**FINDINGS AND RECOMMENDATION  
OFFICE OF PLANNING AND ZONING  
ANNE ARUNDEL COUNTY, MARYLAND**

**CASE NUMBER:** 2023-0130-V

The applicants are requesting a variance to allow a dwelling and associated facilities with less setbacks and buffer than required on property located at 1829 Cove Point Road in Annapolis.

SCALE: 1"=20'  
 DATE: AUGUST 1, 2022 PROJ. NO. LH1292 SHEET 1 OF 2

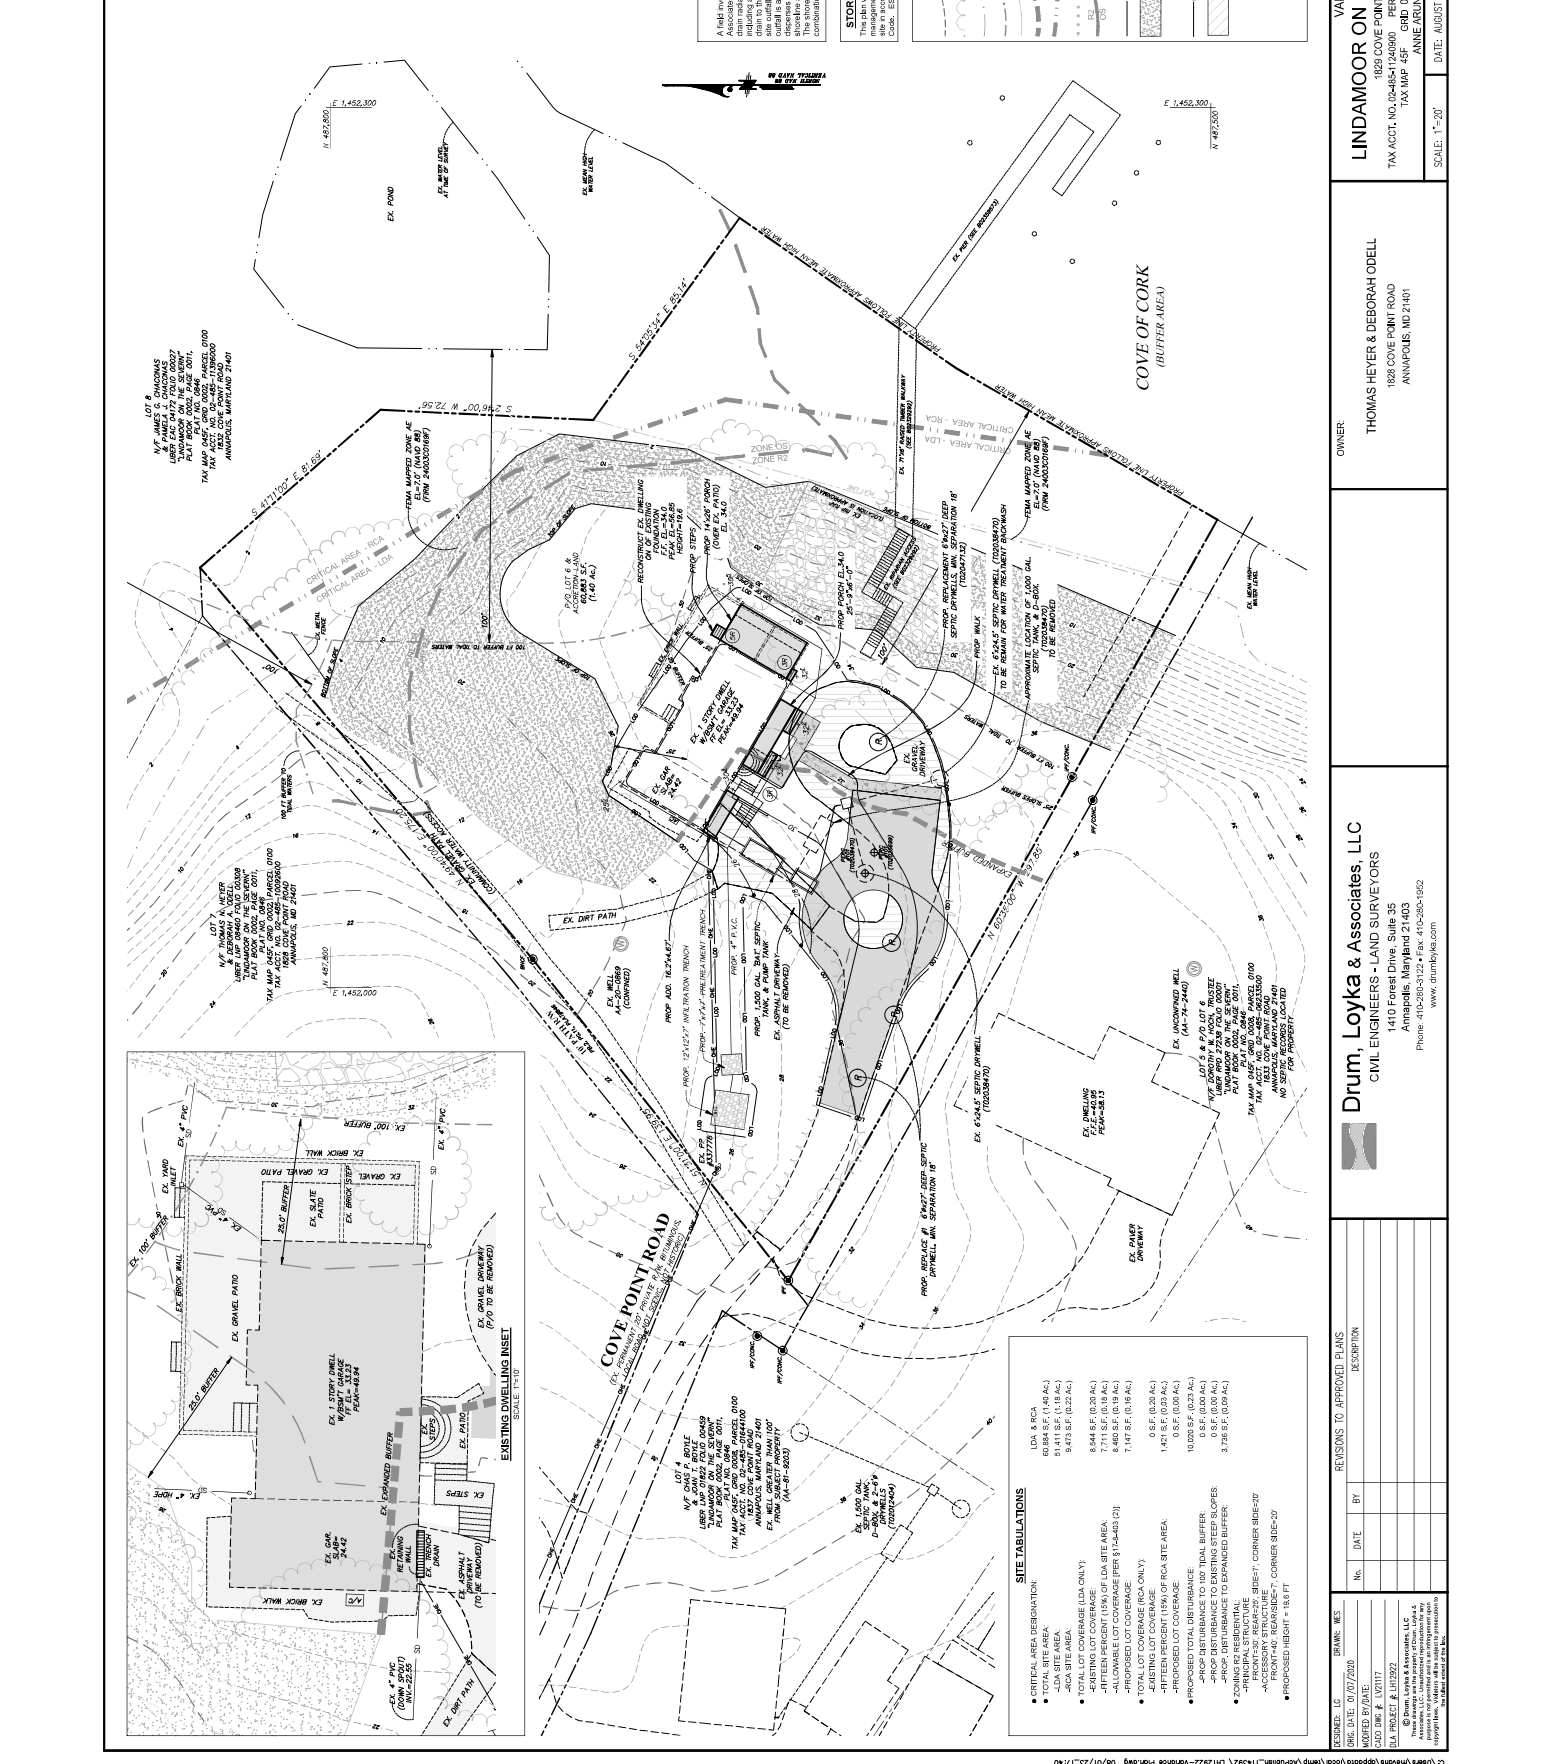
- 1- An infiltration trench with a pretreatment trench is proposed to manage the rooftop runoff. The submitted variance application will need to include soil borings to validate the suitability and siting of the practice. The trench, as shown, drains to a swale that flows to the adjacent private property. It is unclear if the trench is sized for the ESDv or the 10-year flow. A right to discharge permission may be required if the drainage quantity, velocity, and pattern to the swale is altered. The phreatic line from the overflow of the practice must be shown and shall not intersect the steep slopes.

- 2- Submit a SWM report and discuss/locate the existing SWM for the home. All existing SWM must be clearly marked on the plan. Specifically, discuss the SWM provided for the previous variance case 2020-0081, to disturb the expanded buffer to construct an addition and reconfigure the driveway.

- 3- A photo tour and a statement regarding the stability is needed for the steep slopes.
- 4- Submit the private R/W private easement for cove point road.

**Determination** – This office has no objection to the request as long as the comments shown above are addressed with the grading permit application.

HEYER RESIDENCE  
1037 COVE POINT ROAD ANNAPOLIS, MARYLAND  
PROPOSED FIRST FLOOR PLAN  
1004-4-0001  
10/11/2014  
SHEET  
A-2  
1 OF 2

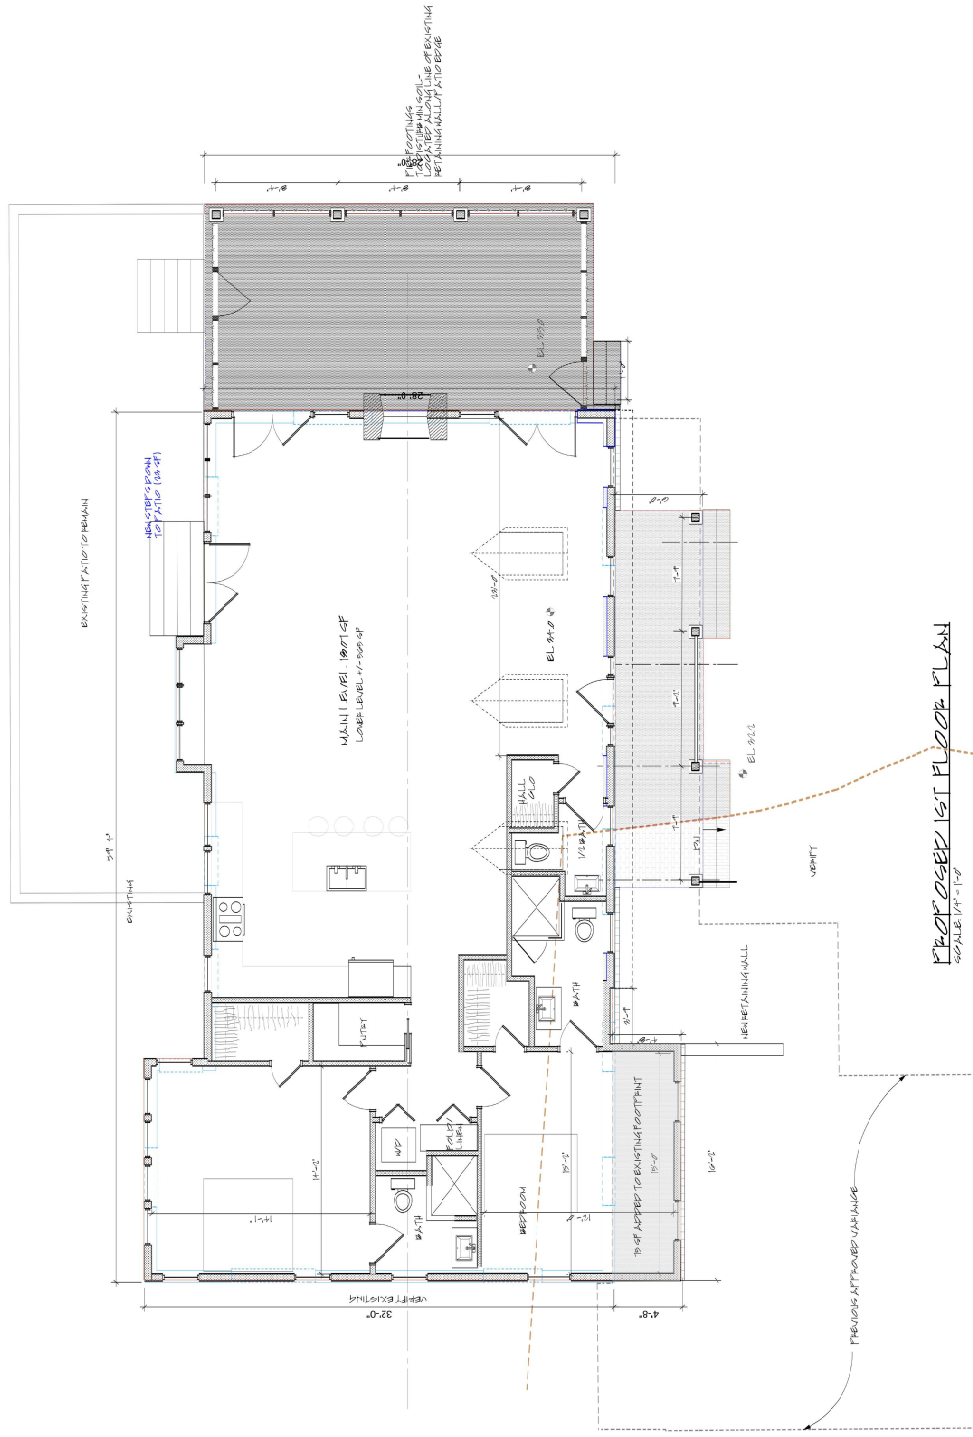
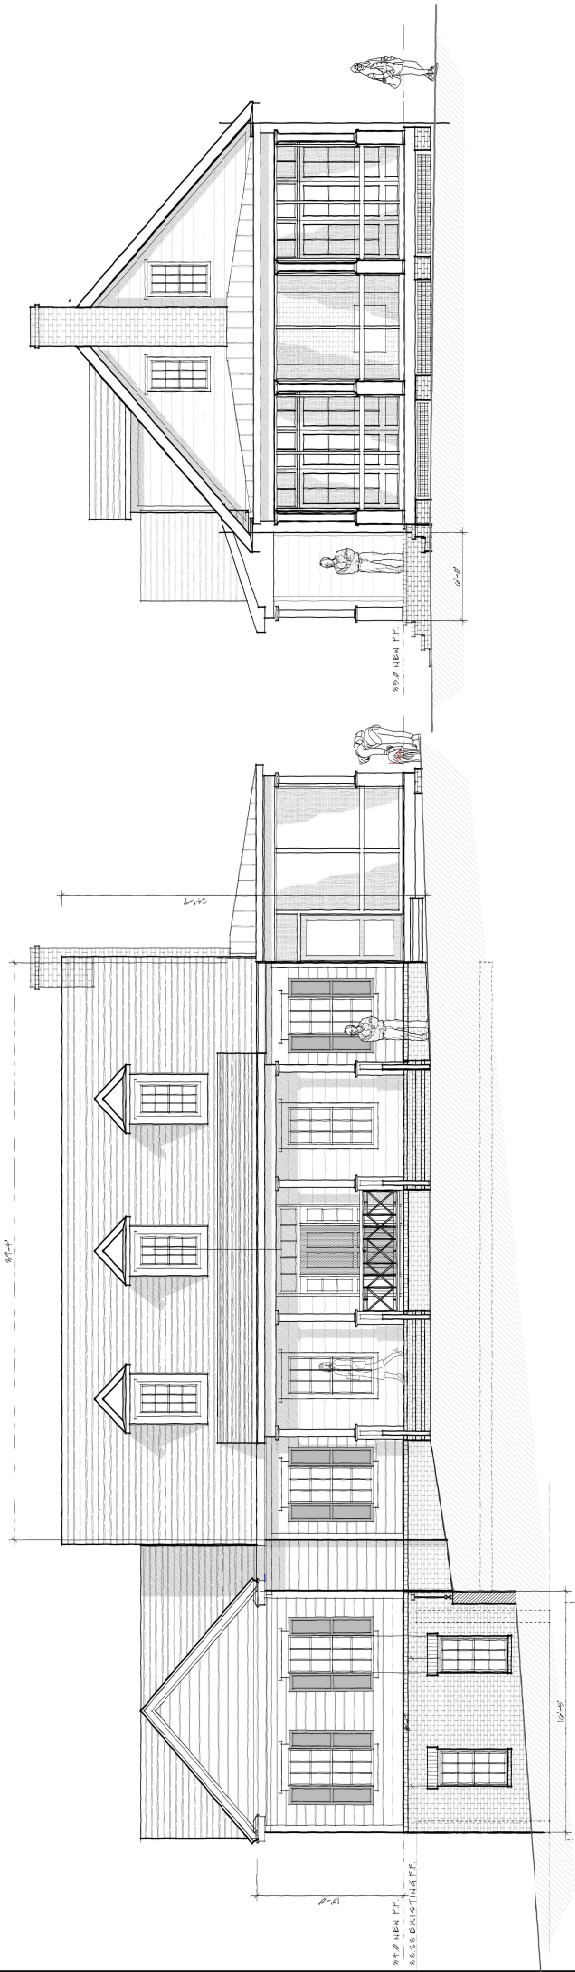
<sup>1</sup> The letter of explanation and site plan indicate that the new dwelling will remain one story with a partial basement and partial crawl space. However, the construction drawings appear to show a one-and-a-half story dwelling. The applicants' representative indicated that there will be no living floor space above the first level. Some areas above the first level will have vaulted ceilings and others will be attic space and HVAC/mechanical.
